MINUTES
OUTAGAMIE COUNTY DRAINAGE BOARD MEETING
JANUARY 6, 2026

Date	12/19/2025
To	Brandon Robaidek, P.E. – Robert E. Lee & Associates, Inc
Cc	Outagamie County Drainage Board
From	Justin Keen, P.E. Cedar Corporation
Subject	North Kaukauna Storage Units Development Storm Water Management Plan Review Vandenbroek Drainage District

10-Year, 24-Hour Storm Flow Rate Calculations
Vandenbroek Drainage District
Outagamie County, WI

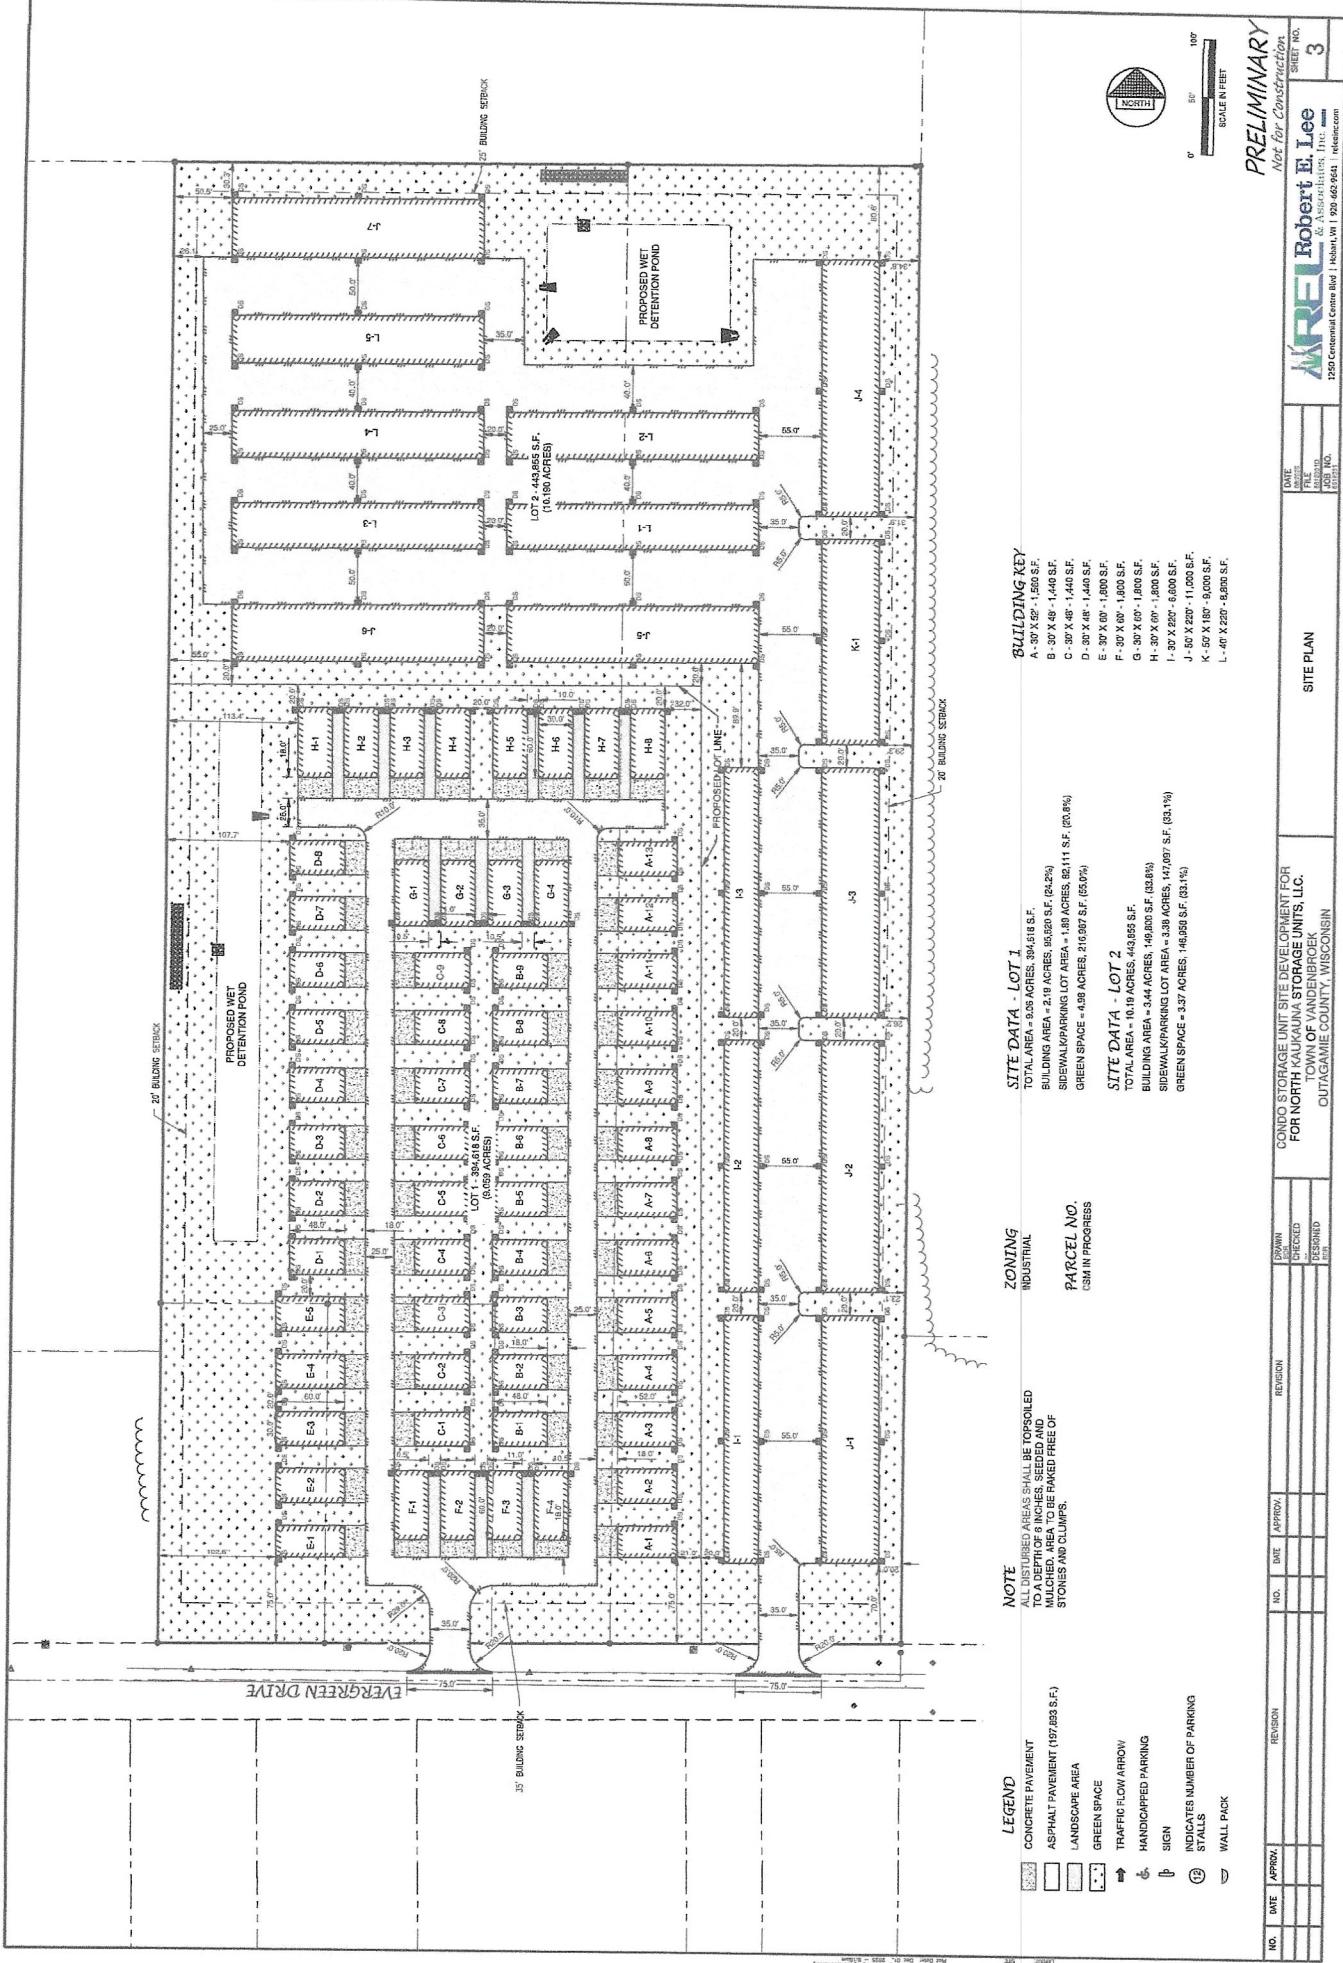
1. Storm water shall be managed to conform to the development's proportionate share of the 10-year, 24-hour discharge identified in the drain to which the connection will be made for the 10-year, 24-hour event (3.8" per Wis. Admin. Code ch. ATCP 48).
 - a. The allowable rate was calculated from the attached calculations table, $40 \text{ cfs} / 271 \text{ acres} = 0.15 \text{ cfs/acre}$. The project site area draining to the legal drain is 19.25 acres according to the report. Therefore, $19.25 \text{ acres} \times 0.15 \text{ cfs/acre} = 2.89 \text{ cfs}$ allowed for 10 year, 24-hour storm event.

Note that there are 2.48 acres of untreated area that cannot be physically collected into the storm water management facilities. These areas are landscaped berm and side slope areas being used to bring the site up to grade. The areas that drain into the storm water management facilities meet the 10 Year Storm Flow requirements. The 2.48 acres of untreated area cause the complete site to not be in compliance with requirements.
